**ITEM #3 - PRELIMINARY PLAT
NOWAG TRACTS SIGLER ADDITION**

KPB File No.	2024-043
Plat Committee Meeting:	May 13, 2024
Applicant / Owner:	Gray and Barbara Sigler of Homer AK
Surveyor:	Jason Schollenberg / Peninsula Land Surveys
General Location:	East End Rd Milepost 6 Kachemak Bay APC

STAFF REPORT

ASBUILT SURVEY

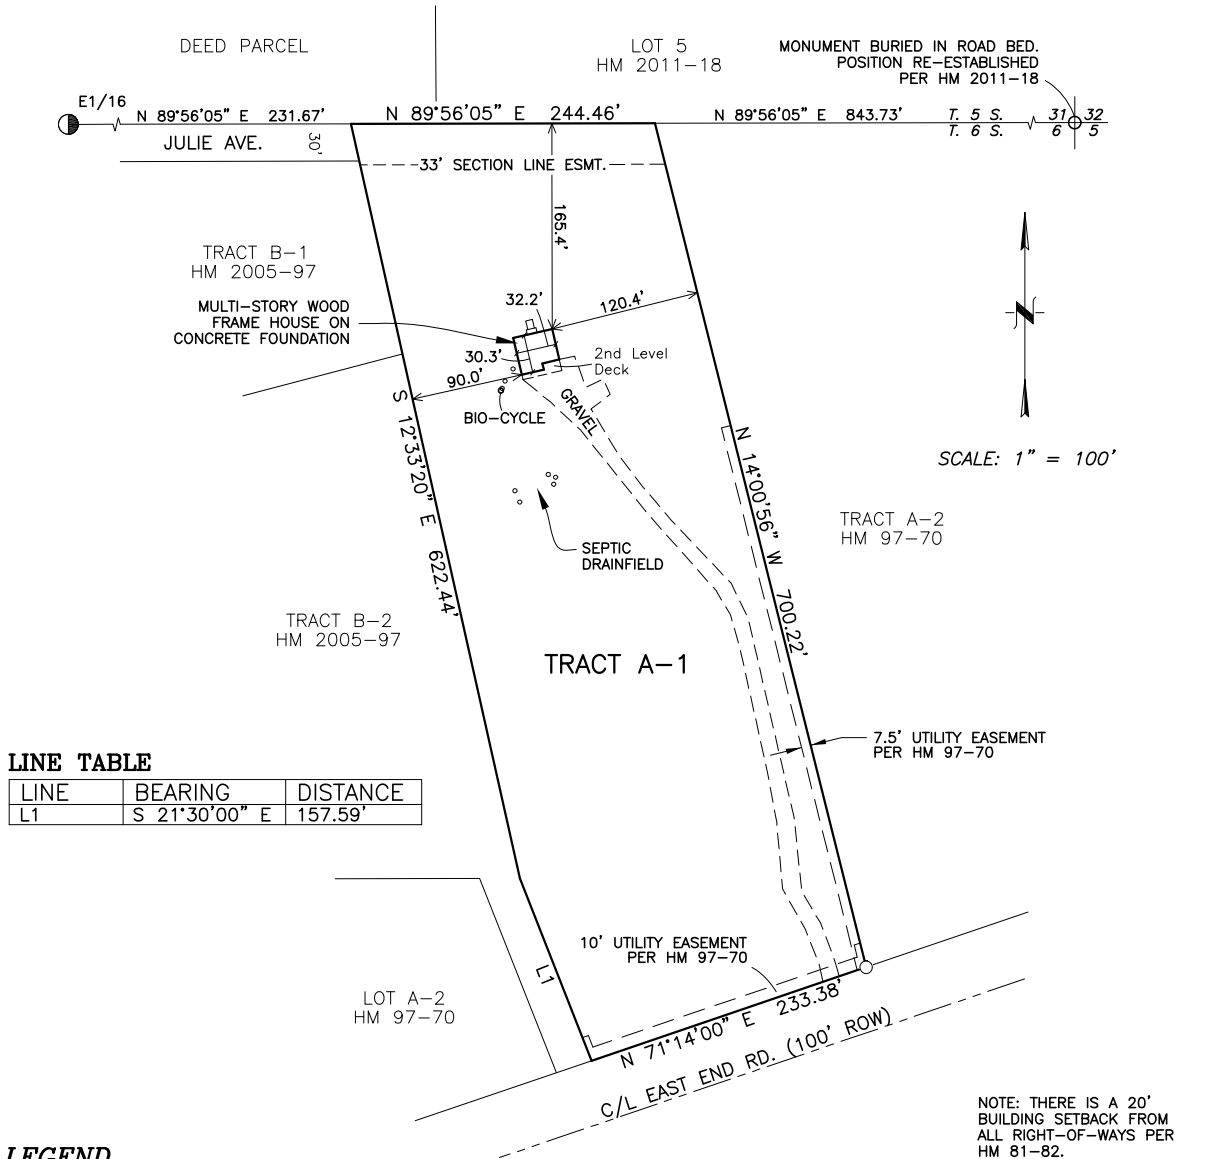
A soils report from the parent plat has been submitted for this plat and is enough to fulfill requirements of submittal. The surveyor should verify that the new system shown on the asbuilt will remain on Lot 3 and meet requirements of ADEC setback limits to property lines as the asbuilt supplied looks close to the proposed division.
